Project No: 460-1
Cesar Chavez/Edward Kemble Furniture
ADDENDUM NO. 2

Question #8: Is this the same item? It looks more like G-17

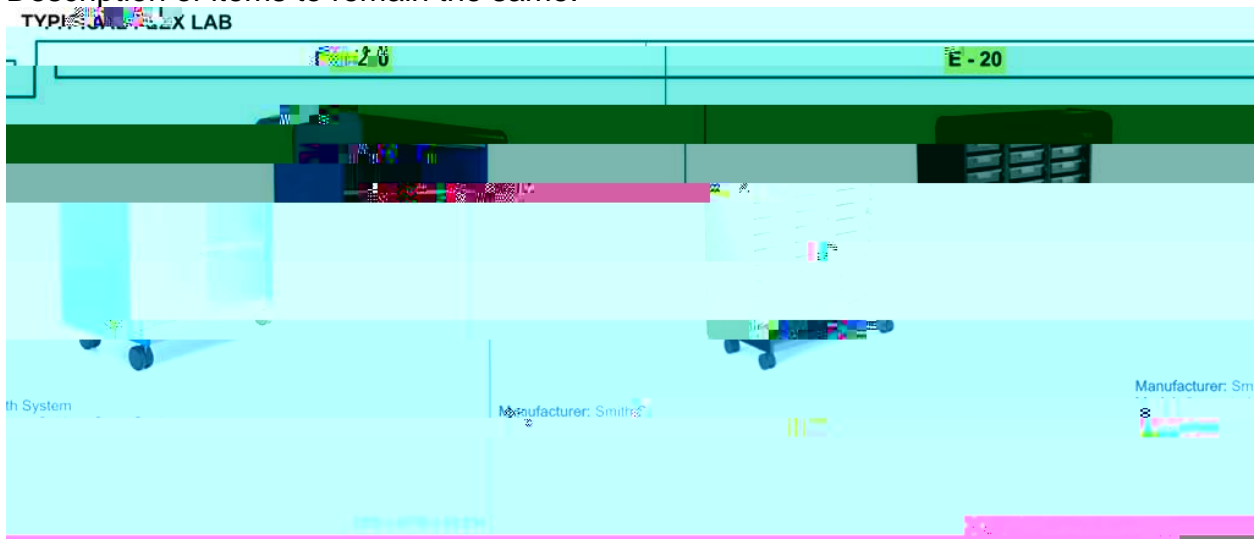
END OF ADDENDUM NO. 2

Acknowledgement of this Addendum will be required at time of bid.
